DESIGN REVIEW BOARD

DRB2016-22

Design Review for new
construction of two
office buildings and
associated site work

BROADWATER BAY BUSINESS PARK - LOT 2B: OFFICE SUITES

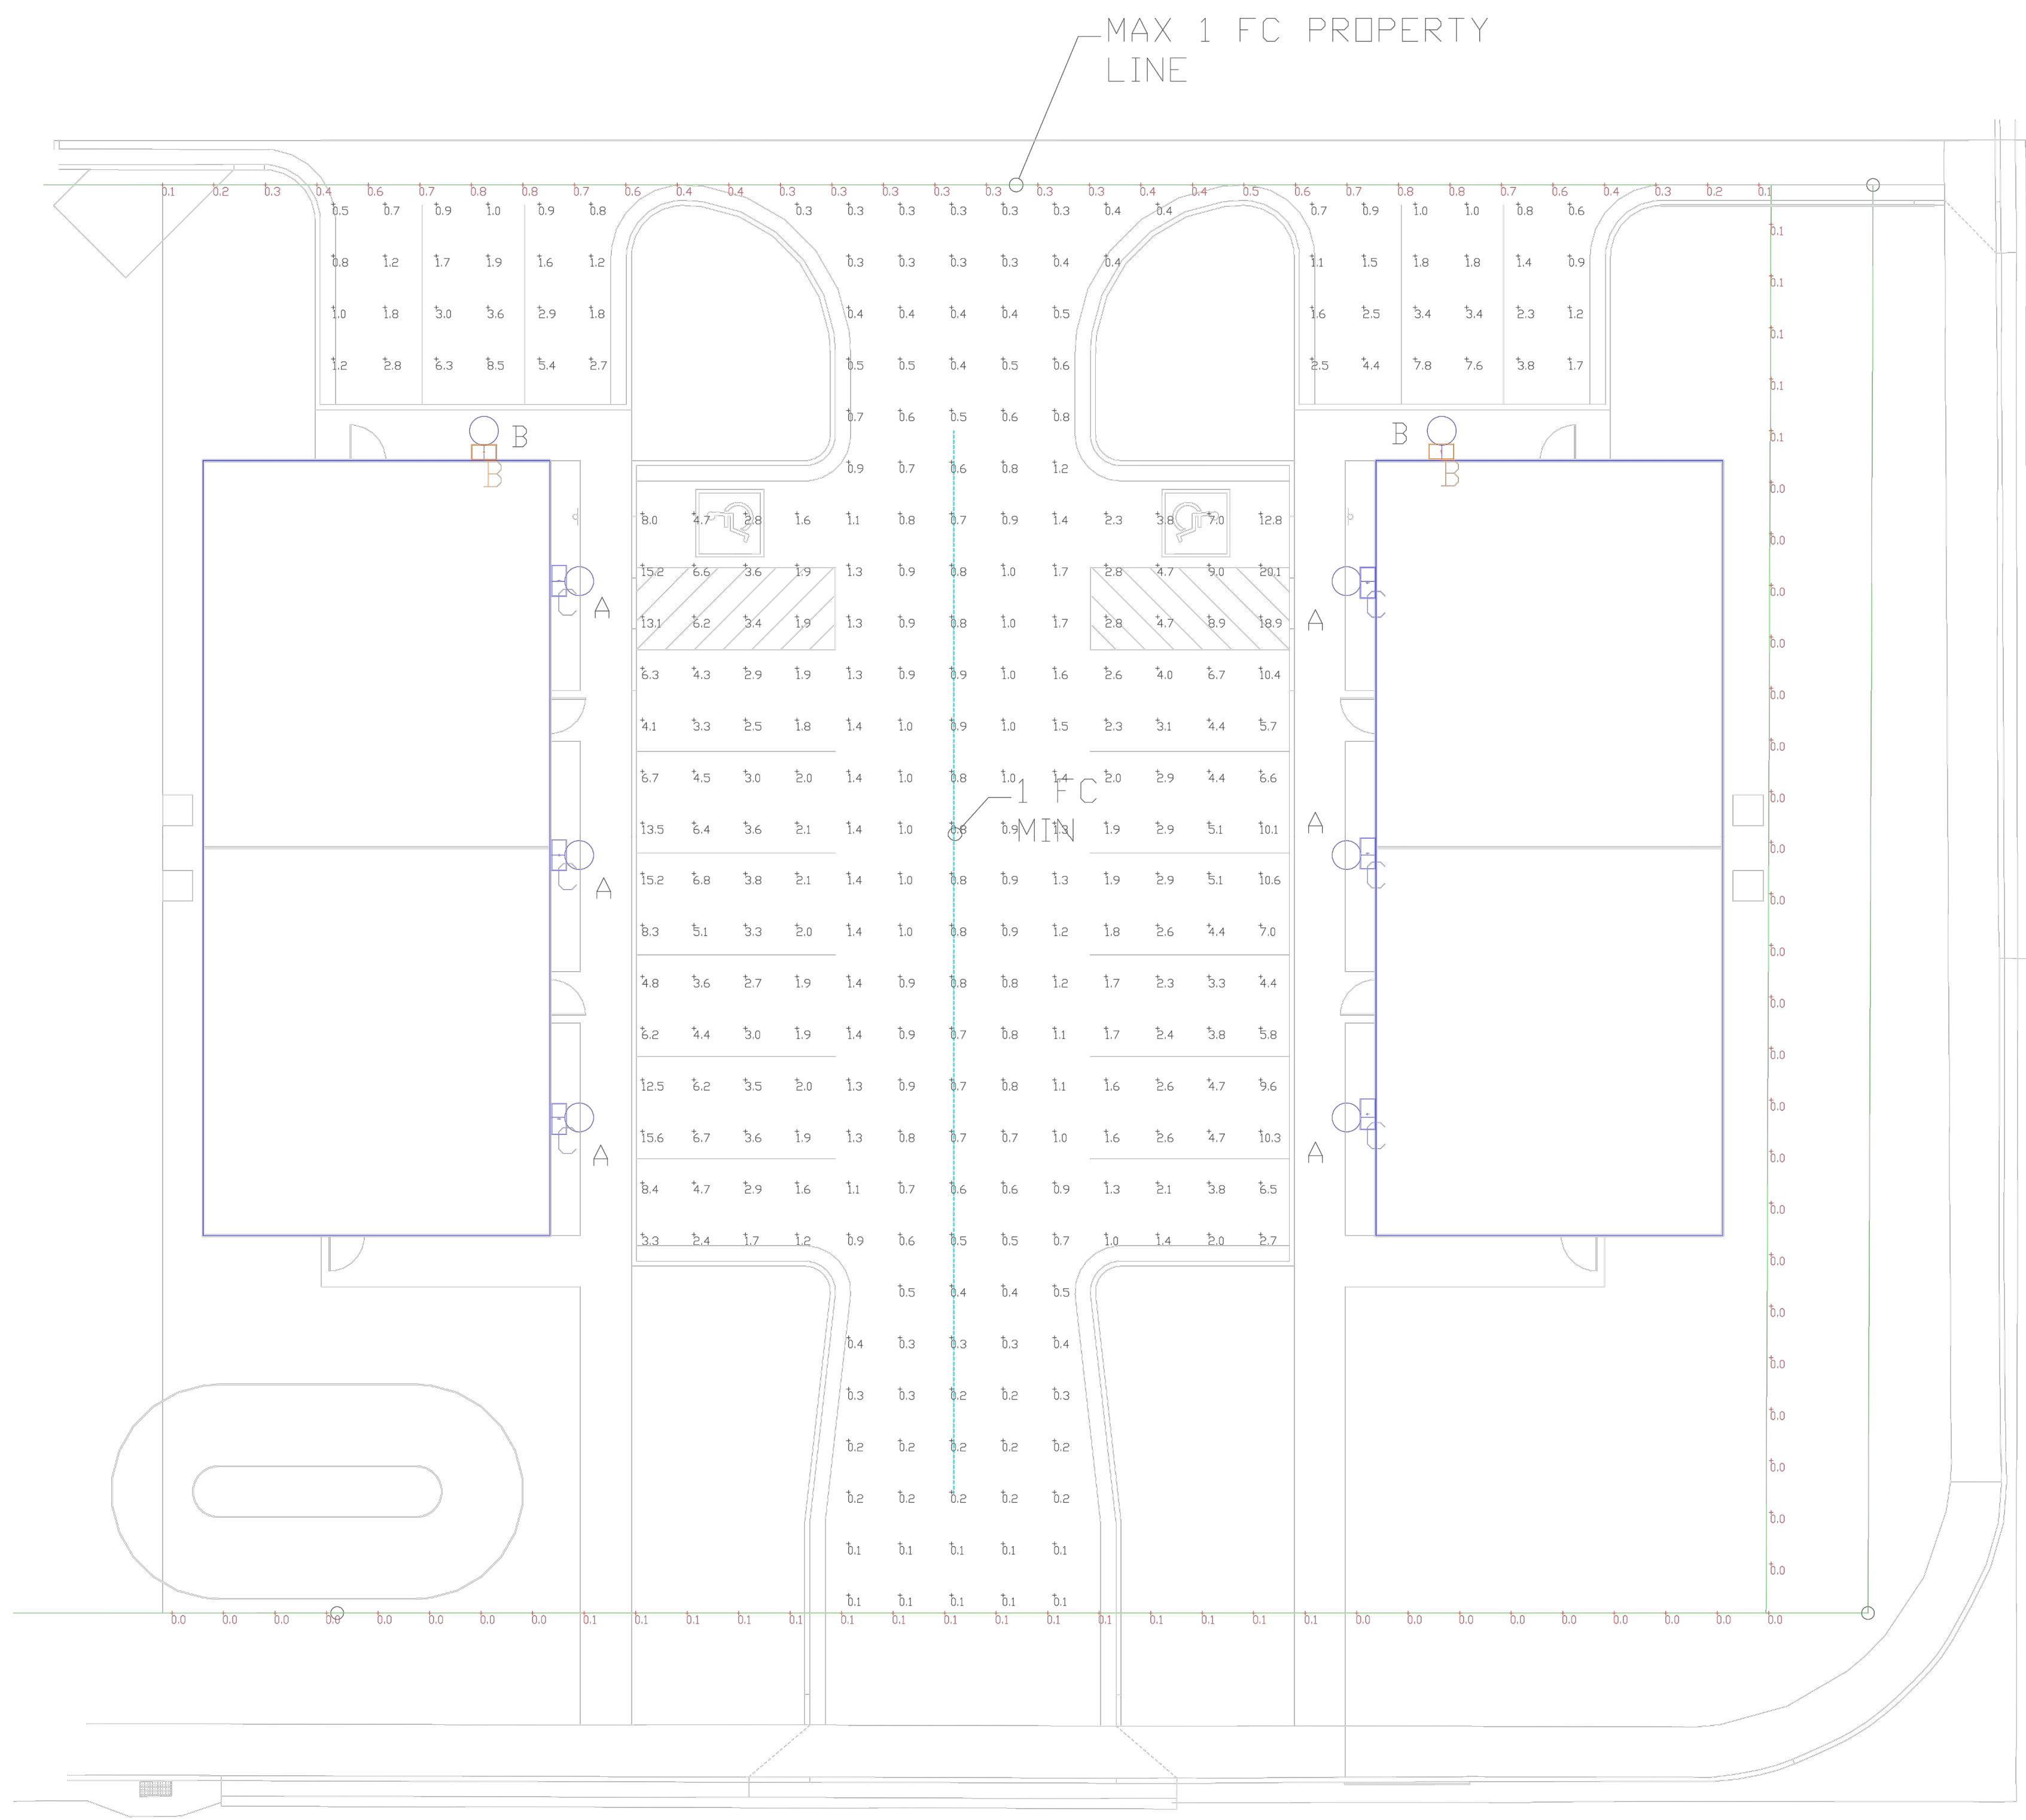
The applicant has provided an outdoor lighting plan which requires modification in order to meet the standards of the OCCGF. The proposed fixture shall be revised to be a full cut off luminaire. This change will affect the foot-candle output for the development. The applicant has responded to the Staff comments provided on the outdoor lighting plan, which includes that the revised fixture will not exceed the 5 foot-candle average per the OCCGF. The applicant will continue to work with Staff through the building permit process to correct all Title 17 deficiencies on the photometric plan.
